## MEETING MINUTES

**Meeting Date:** Thursday, January 5th, 2017 – 10:30-12:00  
**DFD Project Number:** 14120  
**Project:** Wittich Hall Renovation  
**Location:** DFD – 101 East Wilson St. Room 721  
**Purpose:** Wittich Hall – Review Meeting  
**Prepared by:** Michael Eberle, AIA

WISCONSIN HISTORICAL SOCIETY REVIEW 2 – 1/5/17

WITTICH HALL

# WEST ELEVATION – PREVIOUS CONCEPT

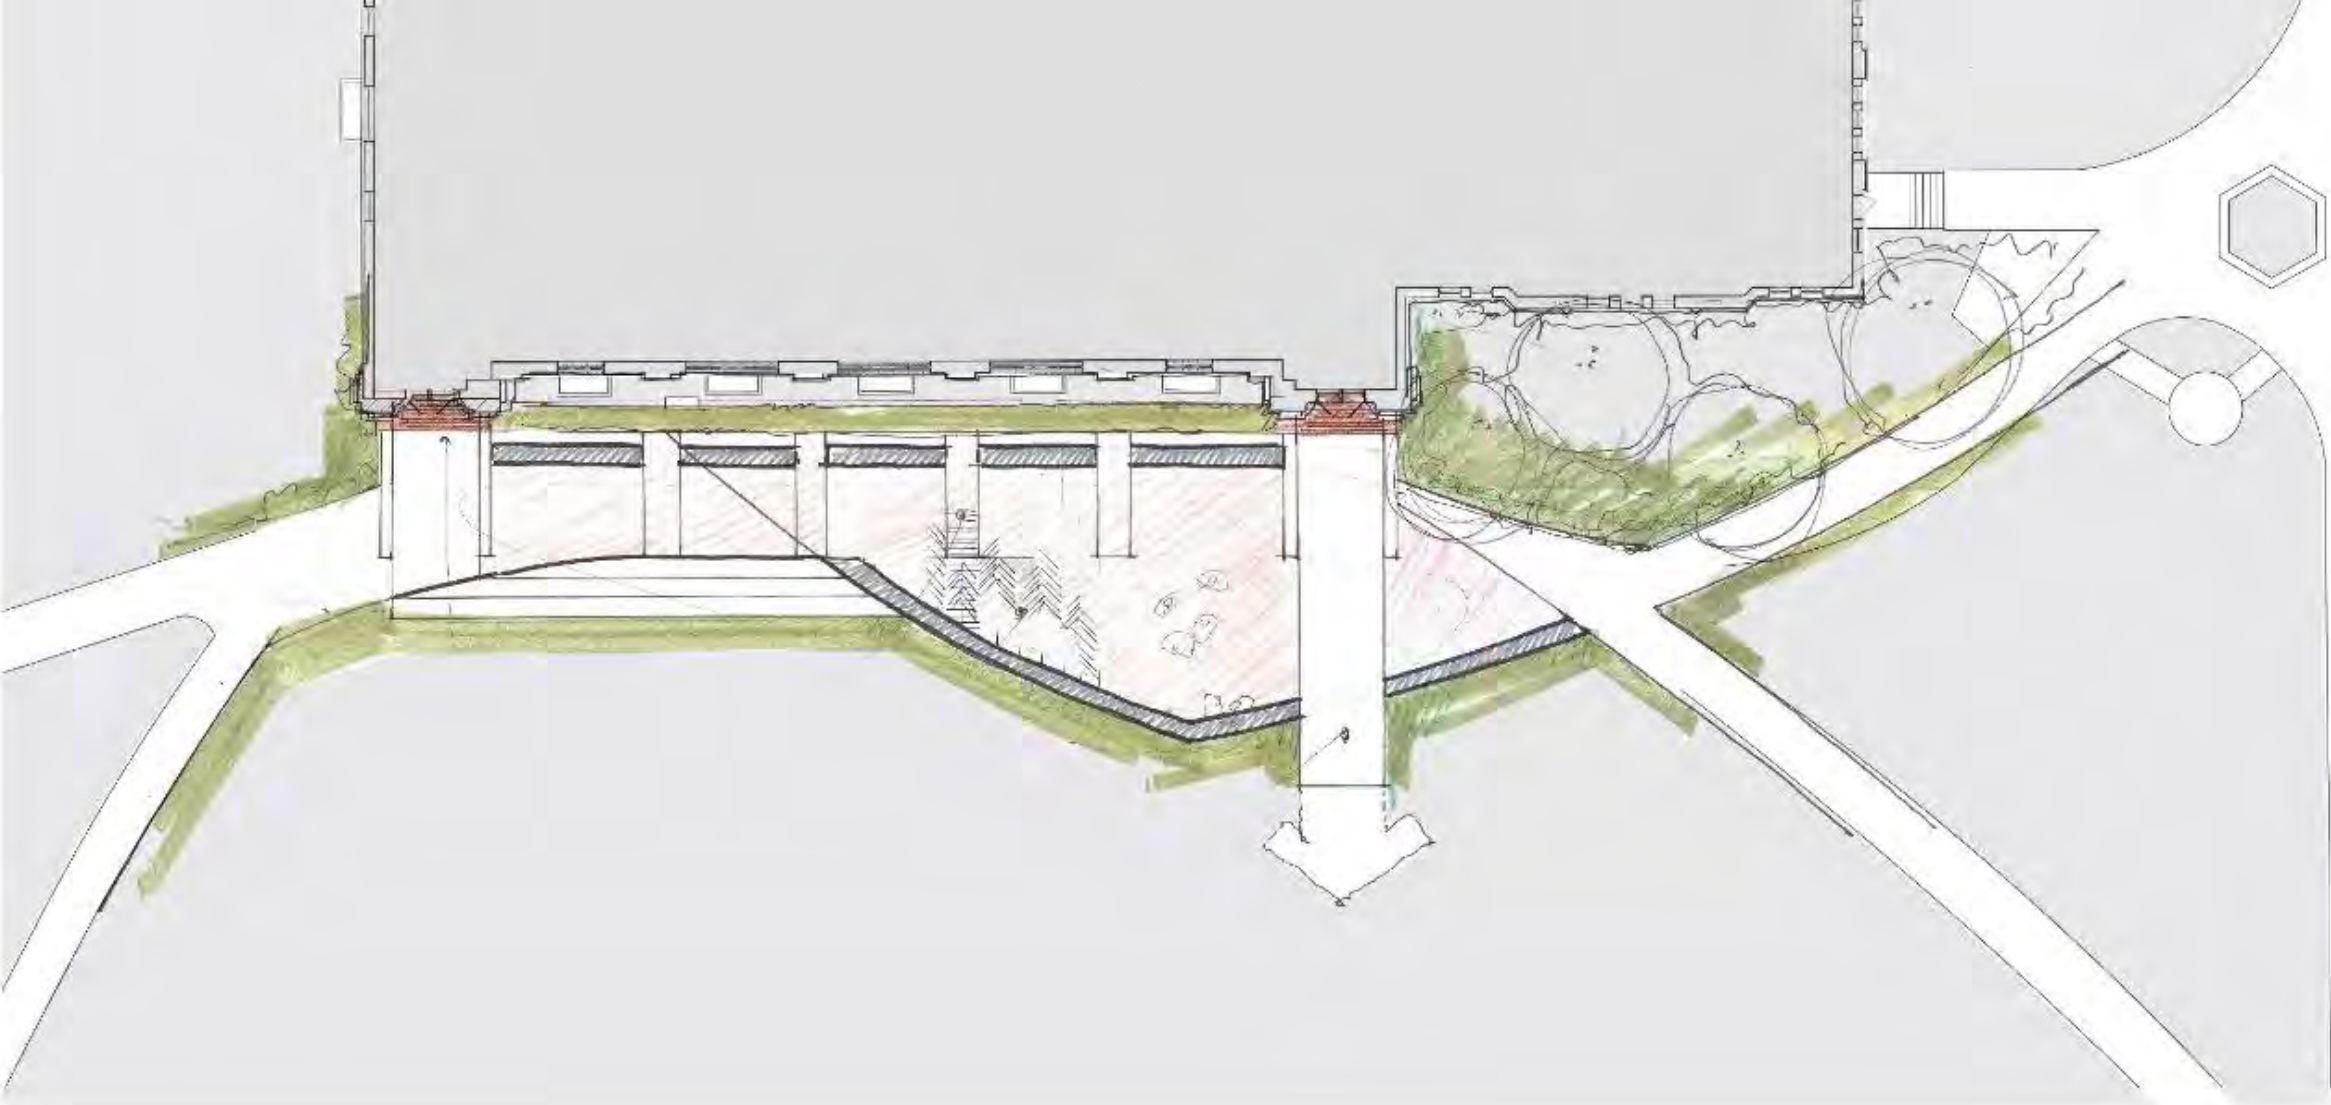
- b. Nate reviewed paths from other buildings for students / faculty utilizing the building.
3. The previous site concept was reviewed including the raised plaza that blocked the view of the building's base.

4. The new site concept shrinks and lowers the north portion of the plaza allowing for more of the building base to be exposed. The NW exterior stairs will be replaced with cheek walls (in contrasting materials and details) in similar configuration to the original NW entry sequence.

**2** NEW ROOF/PARAPET DETAIL  
1 1/2

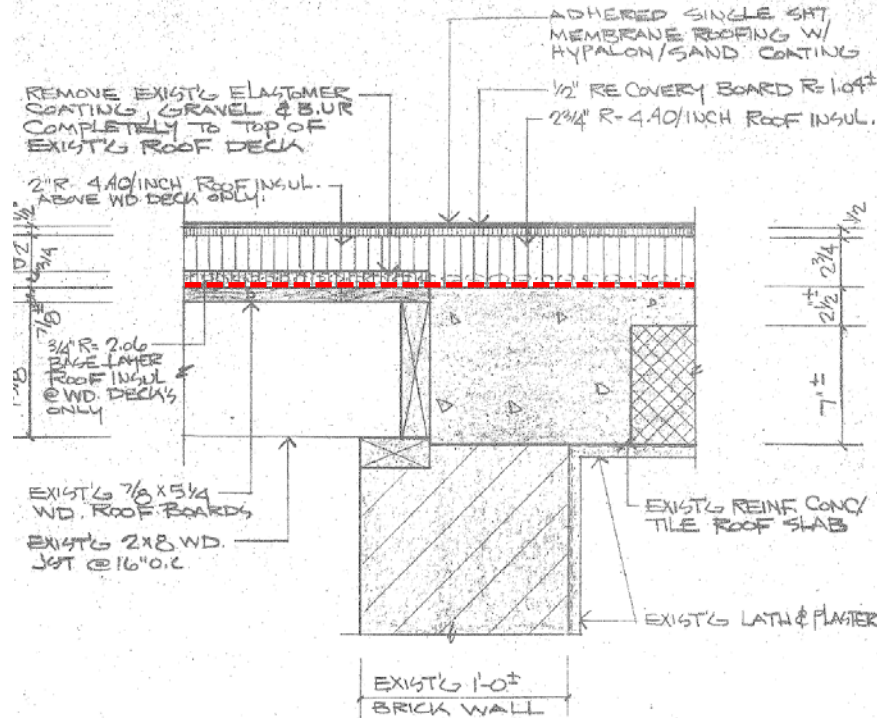
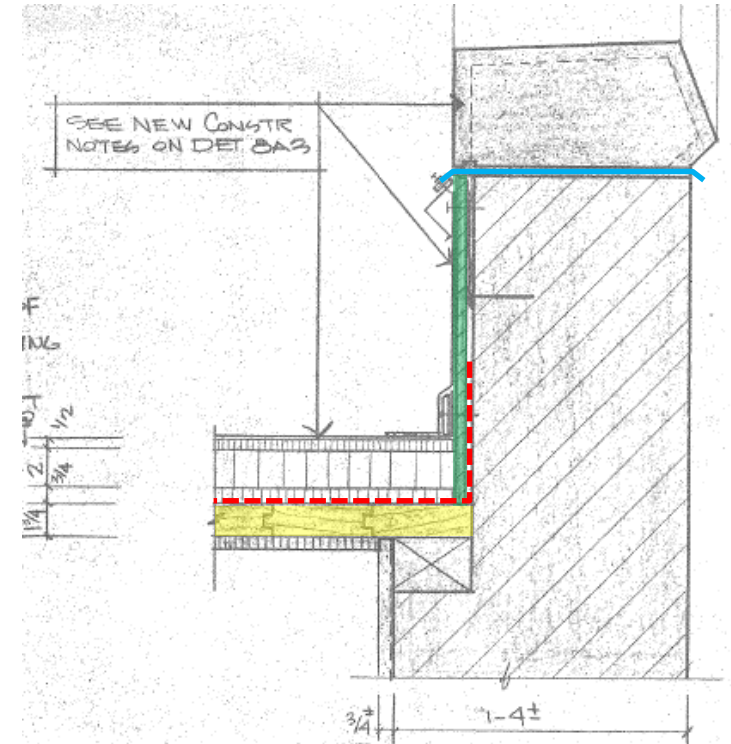
3. The scope of the roof work was reviewed.
  - a. A complete re-roof of the building is planned.
  - b. Insulation will be added to the roof where possible and is limited by the existing parapet heights.

- c. New flashings will be added under the existing limestone coping.
  - d. Drawings / details of the 1980s re-roof were reviewed including added plywood backer panel at the back of the parapets.

- e. The 1930s wing wood roof deck was covered on the interior by an acoustical panel at some point. The team is interested in removing a portion and reviewing the condition of the existing deck. If the wood deck is found to be salvageable, it will be restored and expressed in the new design as originally intended in the 1930 addition.

# NEW FLOOR – GROUND LEVEL

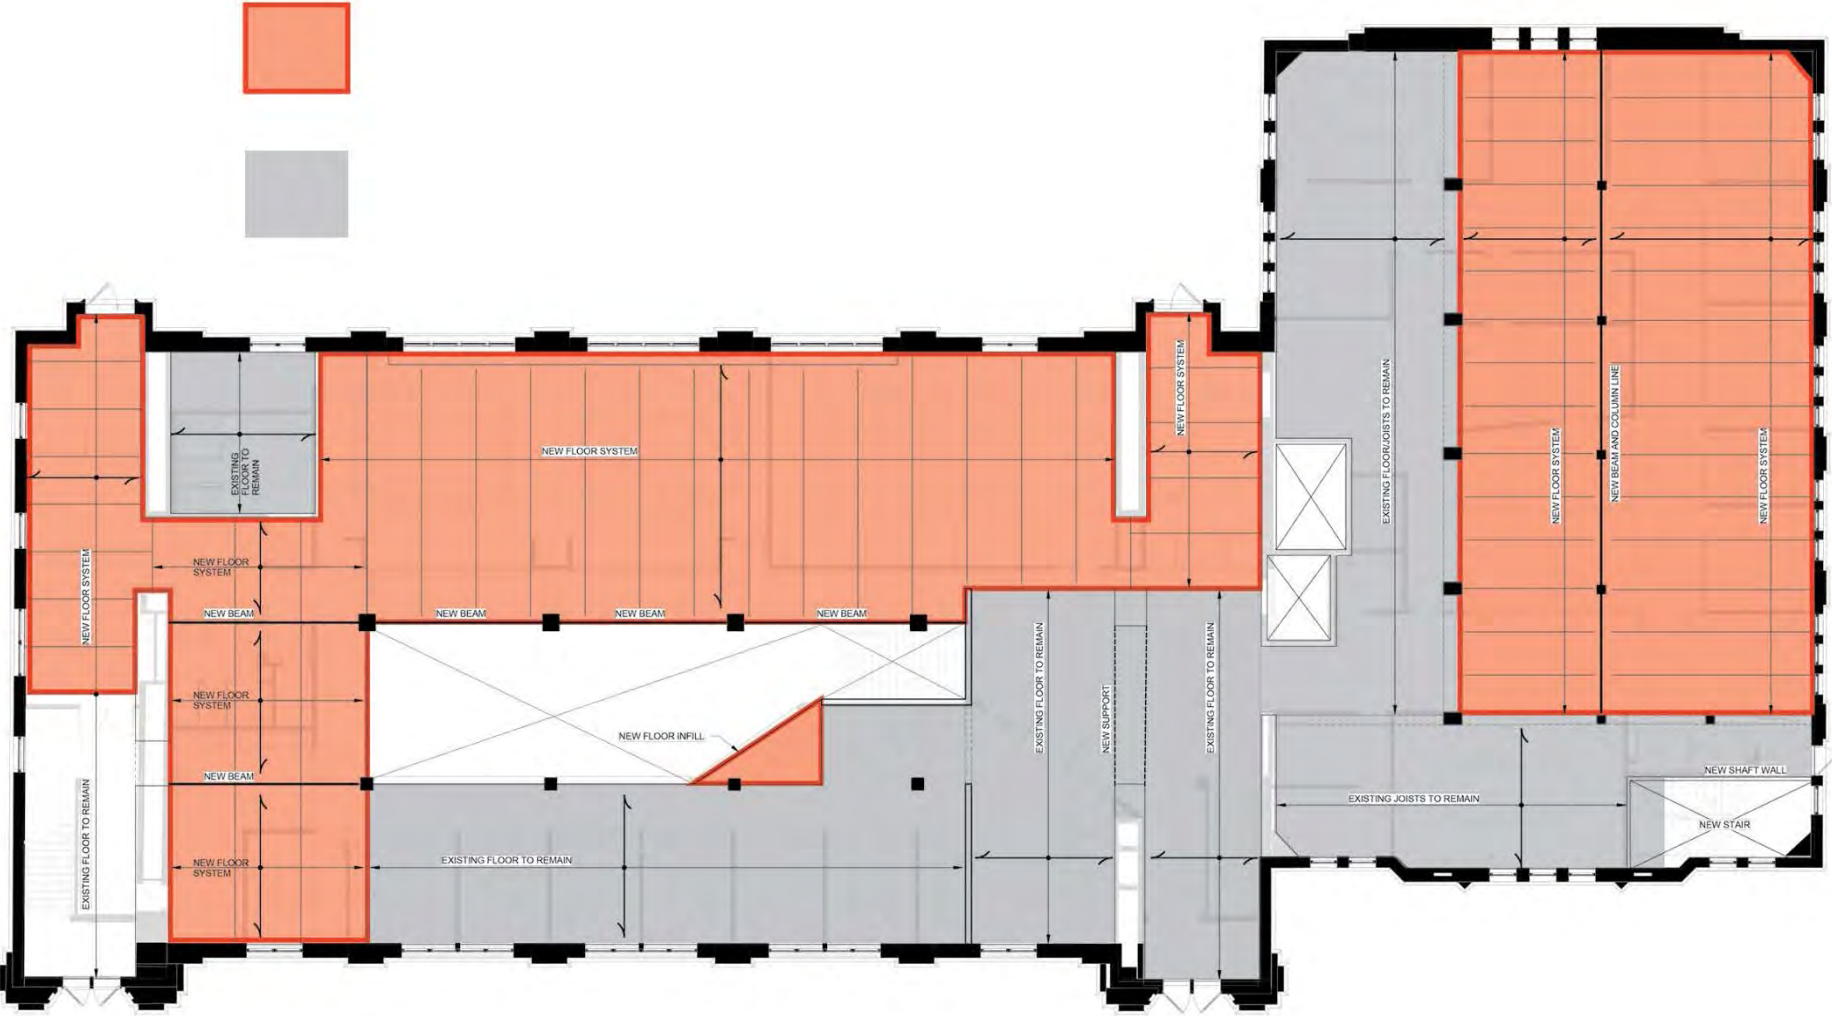
- b. Concern was noted about the new floor opening to the basement as this is not original to the building.
    - i. The center space (where the floor opening is being proposed) was the locker rooms on the first floor.

- ii. She asked how does the floor opening relate to the historic floor plan and did not see connection to the historic use and was concerned with the lack of historic character with the new floor opening.

- iii. She noted concern regarding changing the experience from the primary entry by eliminating the masonry wall and adding the floor opening.
      1. 2 west stair vestibules w/ terrazzo floor material were the defining parts of these entry zones, then the material changed as you turn right or left.

- e. Doug noted that the new goals for the project / program are in conflict with some historic features.
  - f. More definition to the entry was requested. Adding the wall back along the north edge of the SW entry to define entry was agreed upon. The group discussed removing the bench and utilizing that point as access to the open stair. This direction was ok with all.

# NEW FLOOR – THIRD FLOOR

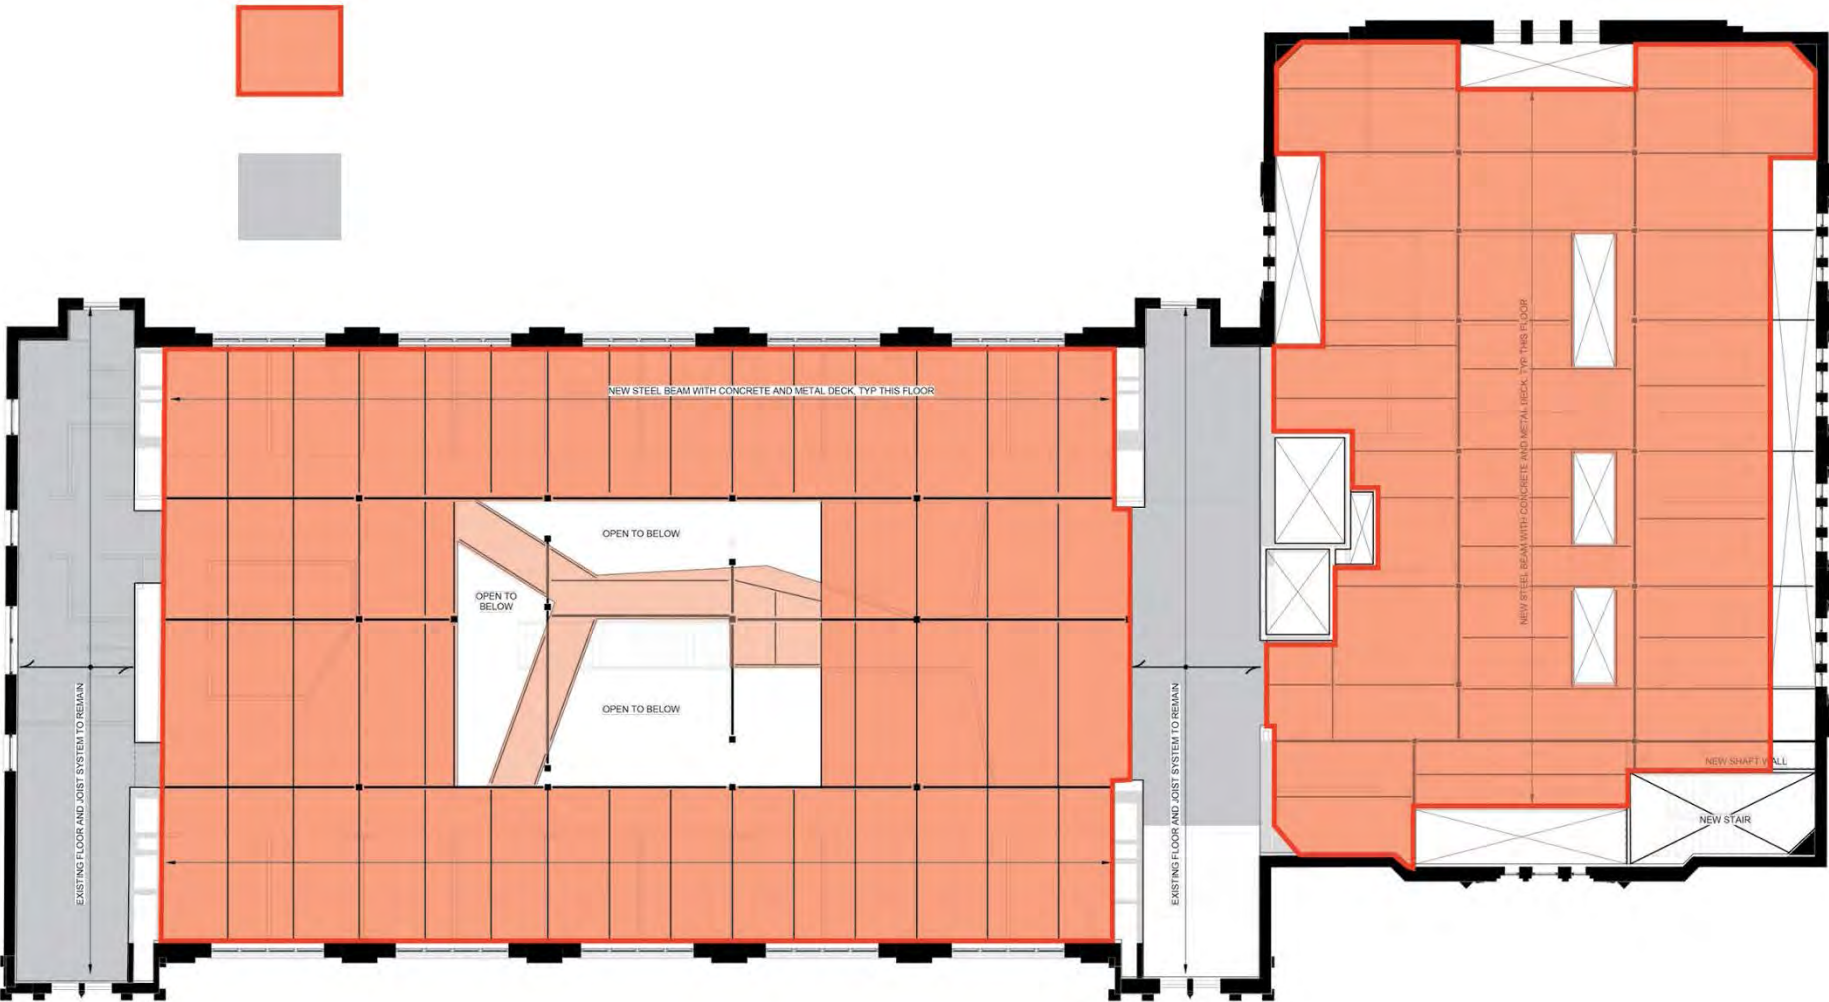
- i. The group also agreed to patching the terrazzo to match the existing where the elevator was installed in the 1970s.
3. In the 1916 wing, WHS is ok with track removal and the new 3<sup>rd</sup> floor layout replicating the track with offices wrapping the perimeter with a floor opening in the center.
